Modified sealing of the guide tube

Sealing ring now included separately in the package

Gearbox: MQ 250

Part no.: 424 0024 10

Figure 1: Guide tube 414 002410 with separate sealing ring

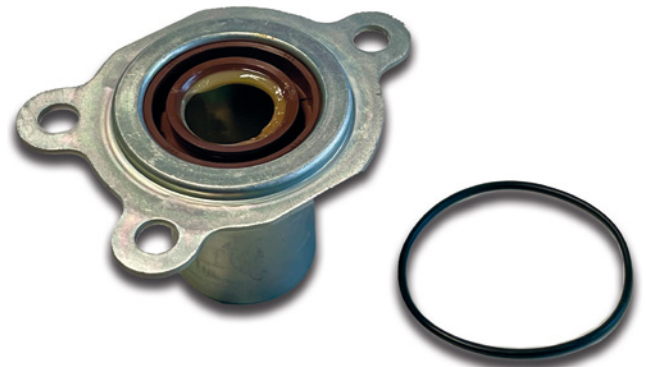
The sealing concept of the release bearing guide tube for the MQ 250 gearbox from the VW Group has been revised. Previously, the guide tube was supplied with a permanently bonded sealing ring. This version is no longer produced. It will be replaced by a new variant.

In the new version (figure 1), the sealing ring is supplied separately. This must be installed on the gearbox side of the guide tube prior to installation. It is not permitted to use any additional sealant.

Previous guide tubes from old stock conform to the technical specifications and can be used without any concerns.
